Access Compliance Report

Public Rights-of-Way

Intersection ID: 48438	Main Street: BARRANDS_LN	Cross Street: LATHERTON_LN	Location: SW
ADA ID: 75262650C7D8	Ramp Type: PerpDiag	Initial Pass/Fail: Fail	Overall Compliance: No
Severity Score: 12.5			
Codes/Mitigation Info/Possible Solution		Field Measurements/Component Compliance

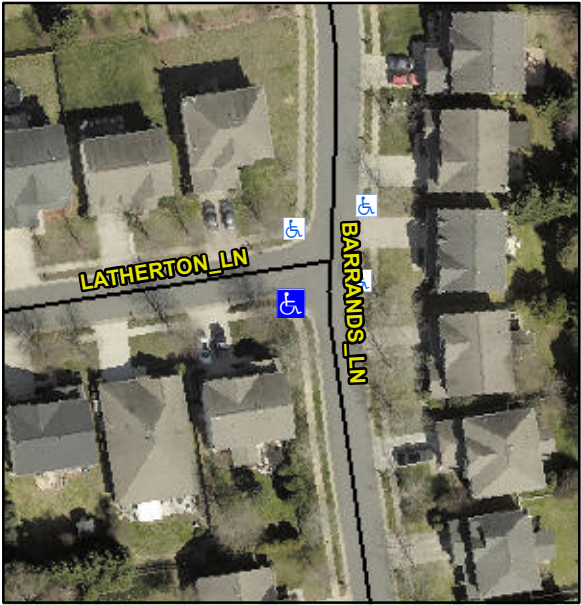
Possible Solutions:				
	Remove & Replace Curb Ramp With Two New Directional Ramps or Equivalent.				
<p>Surveyor Notes:</p> <p>N/A</p> <p>PROW/ADA:</p> <p>R304.2.2</p>			Compliance	Description	Data
			Compliance	Description	Data
<p>Street 1 Name</p> <p>Stop Condition-Street 2</p> <p>Street 2 Name</p> <p>Stop Condition-Street 1</p>			N/A	Ramp Length (in)	46.5
			Yes	Ramp Width (in)	48.0
<p>BARRANDS LN</p> <p>LATHERTON LN</p> <p>StopSign</p>			N/A	Flare Type LT	N/A
			N/A	Flare Slope LT (%)	N/A
<p>Total Cost:</p> <p>\$ 3200.00</p>			N/A	Flare Traversable LT?	N/A
			N/A	Landing Length (in)	N/A
			N/A	Landing Width (in)	N/A
			N/A	Landing Slope (%)	N/A
			N/A	Landing X Slope (%)	N/A
			N/A	Landing Curb? (Y/N)	N/A
			N/A	Shared Landing?	N/A
			N/A	Gutter Ponding?	N/A
			N/A	Gutter Lip Ht (in)	N/A
			N/A	Painted X Walk1?	No
			N/A	X Walk 1 Direction	To E
			N/A	X Walk 1 Width (in)	N/A
			N/A	X Walk 1 Slope (%)	3.0
